Waitaha Hydro intake site – an update on design features in relation to landscape, natural character and visual amenity

Following the Minister's decision on the Waitaha Hydro Scheme concession application Westpower has undertaken a further comprehensive design assessment to determine whether the Scheme's intake structures can be altered to reduced the effects on natural character. With the input of a number of experts (landscape, engineering, tunnelling and surveying) Westpower is now proposing an amended intake design. As can be seen from Figures 1 and 2 below this new design will reduce the effects of the Scheme on natural character.

Figure 2 – New visual simulation of the intake (after 10 years)¹

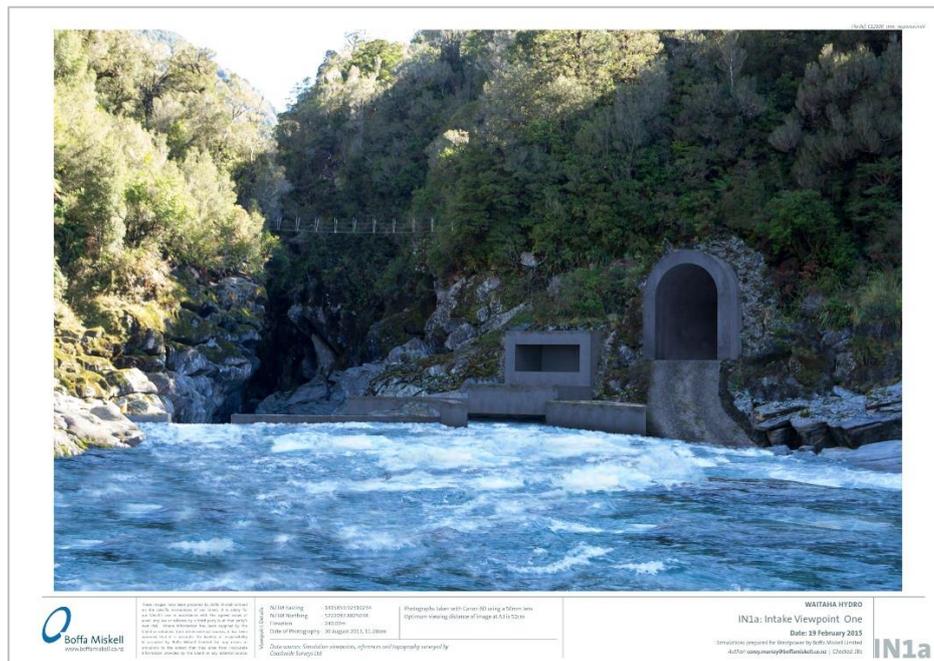
However, Mr Black (tunnel specialist) has advised Westpower that a smaller five-tonne digger would be sufficient for the construction and maintenance, reducing the size of the access portal required to 3m x 3m. This smaller access portal would still provide enough space for bringing construction equipment on site and storing the digger. This is a significant reduction in the size of the access portal, resulting in a considerably smaller opening in the rock.

In addition, as part of Option 1 (and equally applicable to all the options below) the consultant group agreed that the material exposed at the entrance to both portals, which was previously strengthened with shotcrete and portrayed in simulation images as geometrically (arch) shaped concrete blocks, could be altered. The consultant group agreed that the strong rock composition at the site will make it possible to leave the rock uncovered, displaying the natural shape of the stone. In fact, it was recommended to blend it in with the natural lines of the surrounding schist when designing the shape of the portal, so that it "respects the natural characteristics of the area, aligning the portal entrances

- The size of access portal reduced to 3m x 3m
- Portal entrance featuring natural rock as opposed to concrete
- Shape of portals reflecting the natural layering of schist.
